Colonel Richard Hansen's 11/7/2013 Letter

Subject: GDE Mitigation Bank Compliance
Date: July 22, 2013

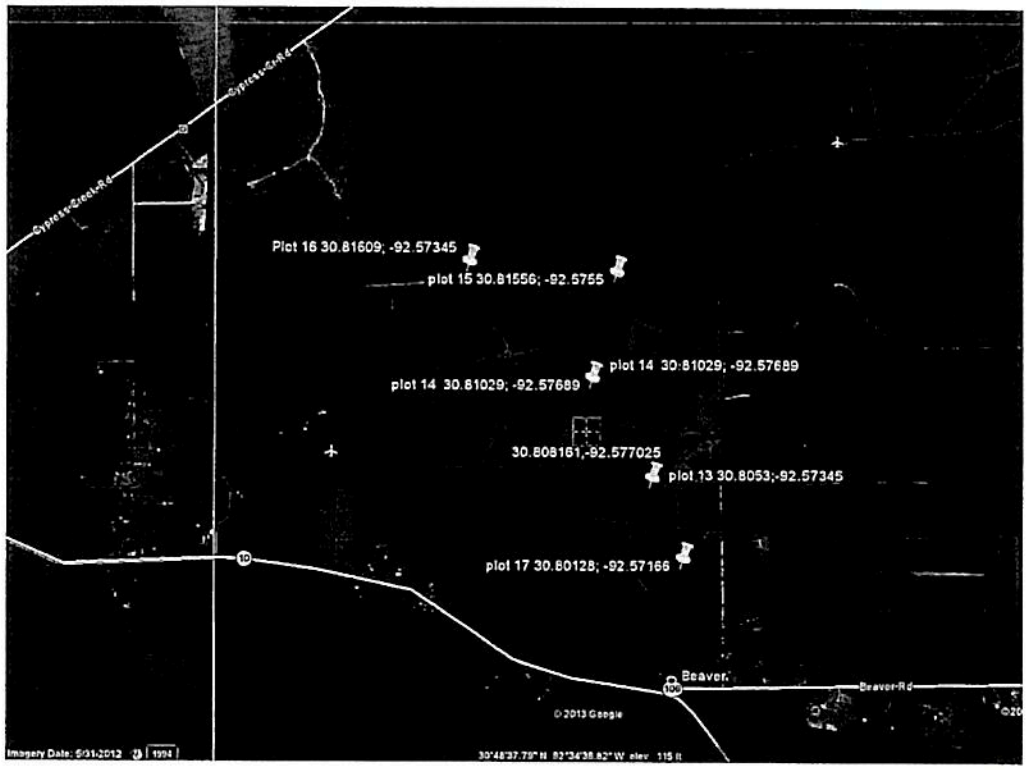
5. Please add additional bank monitoring plots as indicated on the map below. These plots are numbered 13 through 17 and have Latitude and Longitude assigned to each plot. Please provide the additional information for these plots in the monitoring report format. These 5 plots will be additional permanent plots set up as stated on page 7 (Section VI. C. of the MBI) and included in all monitoring reports herein.

Preliminary Jurisdictional Determination

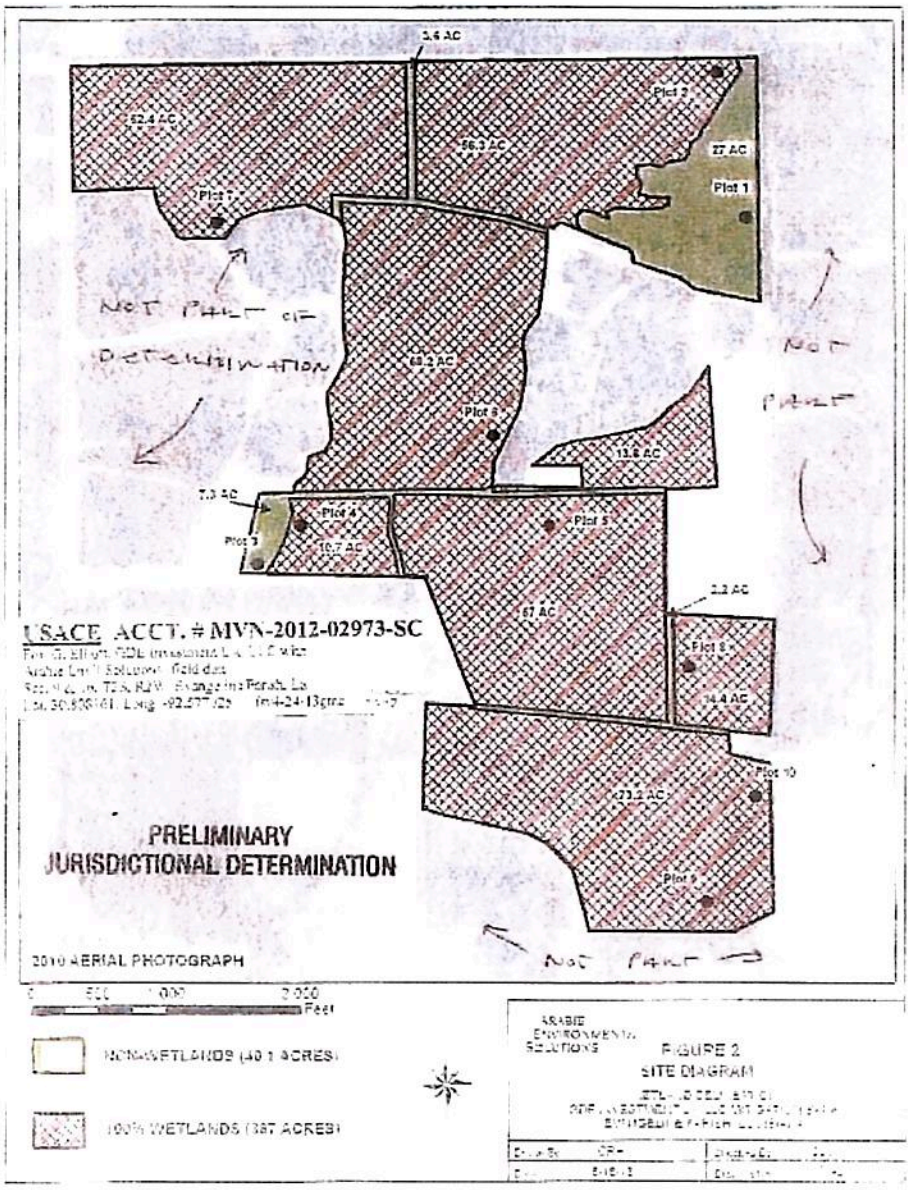
3. Please refer below to the copies of the maps that were provided with your August 21, 2012, monitoring report and compare them to the July 8, 2013, JD (copy attached). After your comparison please provide a separate map showing where the 278.3 acres from the 2007 and 2009 plantings are located on the JD.
